SERVICE NO. 1218A LETTER

Service Letter (SL) 1218A supersedes SL 1218 in its entirety. Aircraft that were previously made compliant with SL 1218 are in compliance with SL 1218A.

CREW SEAT CONTROL CABLE MODIFICATION

Figure 1, Sheet 1 of 2
Crew Seat Adjustment Cable Installation

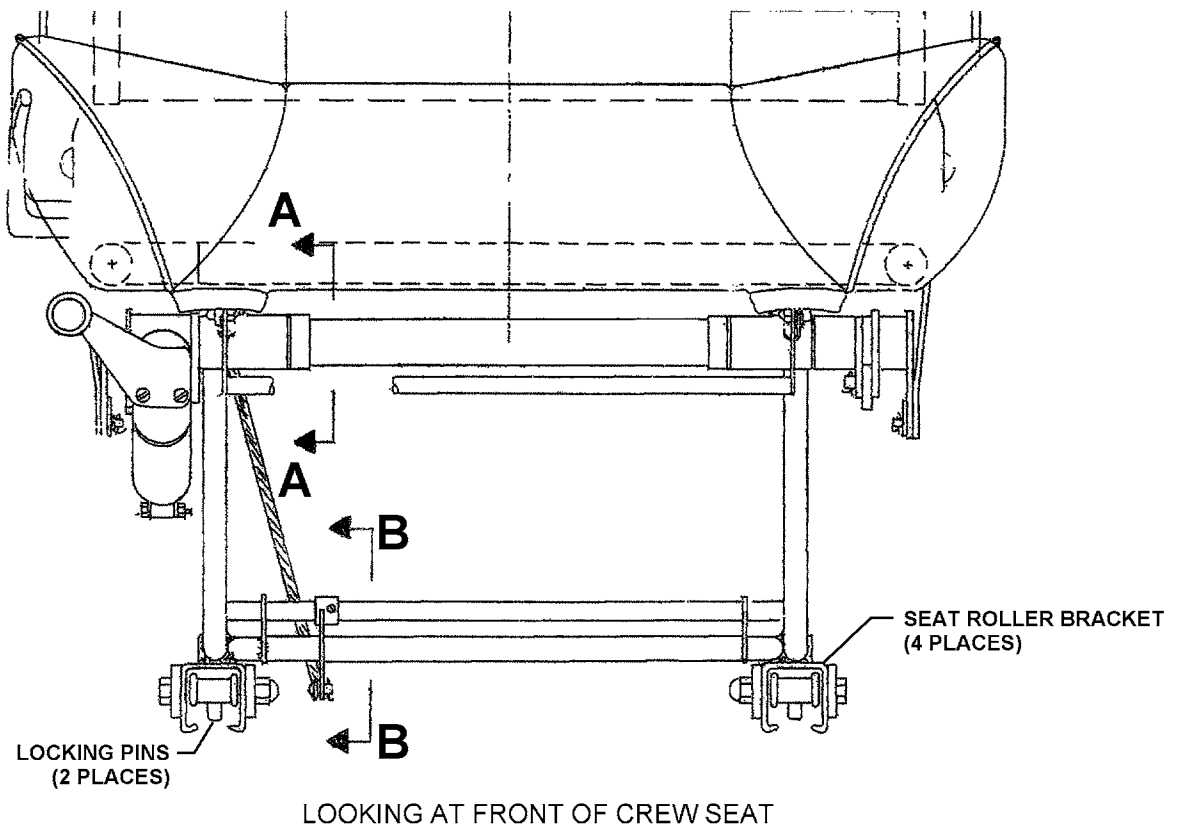
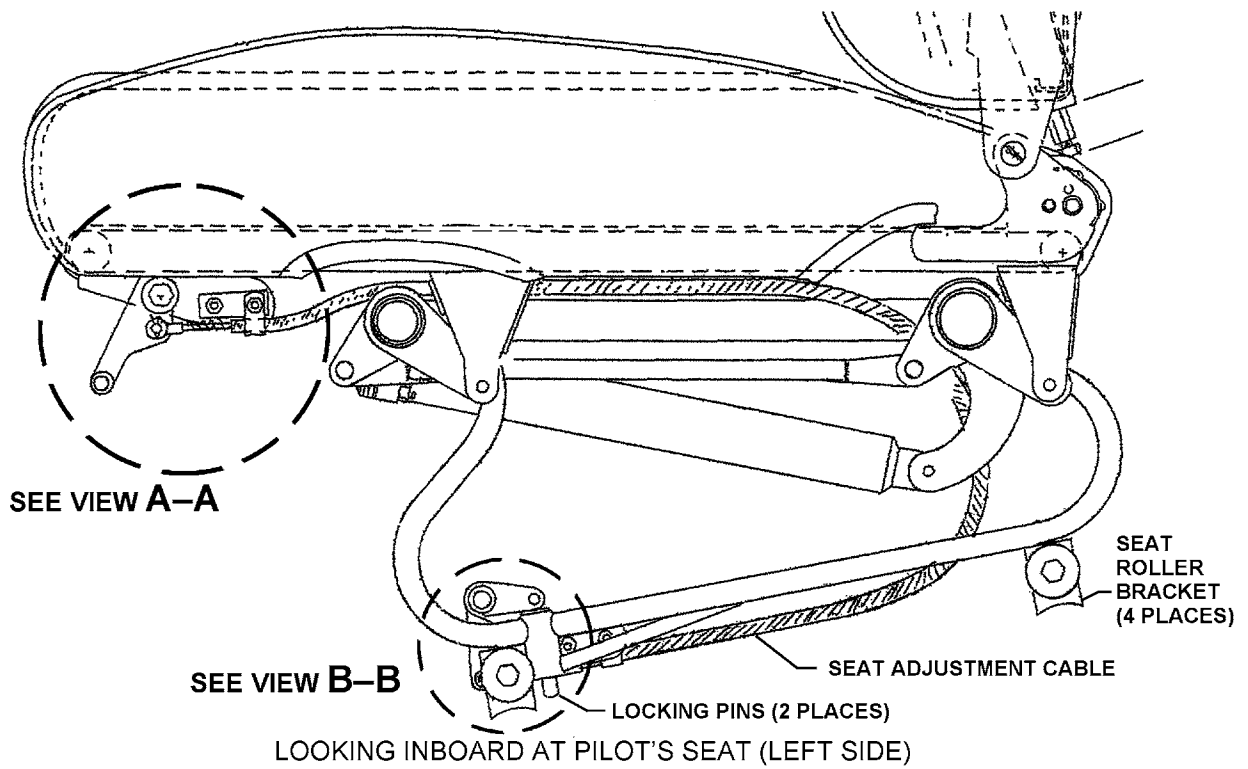
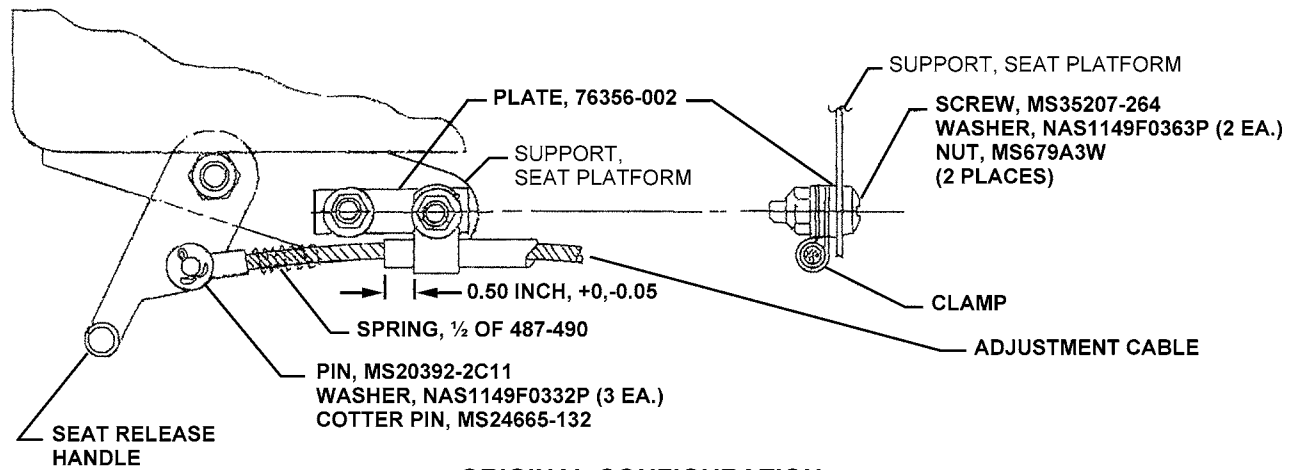
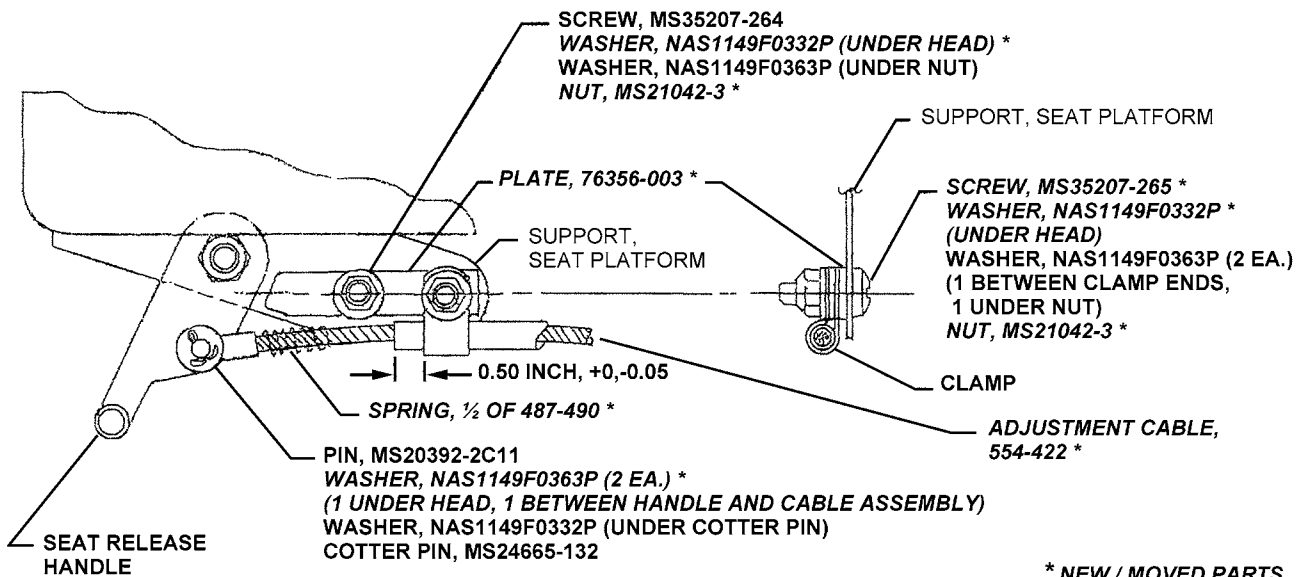
1. The modification consists of replacing the existing seat platform support plate (P/N 76356-002) with a longer version (P/N 76356-003) which limits aft travel of the seat release handle assembly. If the seat release handle assembly is allowed to freely travel aft it can cause the adjustment cable to kink which contributes to unnecessary wear on the cable and shortened service life. Some of the associated hardware is also replaced.
2. The following steps address replacing the cable in one seat (refer to Figure 1):
 - a. Remove and discard the old adjustment cable.
 - b. Install the new adjustment cable as follows:
 - 1) Cut the new spring (Piper P/N 487-490) in half.
 - 2) Install a half of the spring onto the upper end of the new adjustment cable: Rotate the cut end of the half spring onto the cable, and continue to rotate the half spring until it is on the cable as shown in View A–A.

- 3) Route the cable as shown in Figure 1. Take care to ensure the upper and lower ends are correctly positioned.
 - 4) At the bottom right side of the seat base assembly, capture the cable with the P-clamps and loosely install the P-clamps to the seat bottom base assembly with screws, washers, and nuts.

- 5) Position the cable housing end as shown in View B–B and secure in place by tightening nuts evenly at the P-clamps.
 - 6) Connect the cable to the seat release arm by installing the pin, washers, and cotter pin.

- 7) At the upper right side of the seat base assembly, capture the cable with the P-clamps and loosely install the new plate (P/N 76356-003) and P-clamps to the seat platform support with screws, washers, and nuts.

- 8) Position the cable housing end as shown in View A–A and secure in place by tightening nuts evenly at the P-clamps.
 - 9) Connect the cable to the seat release handle by installing the pin, washers, and cotter pin.
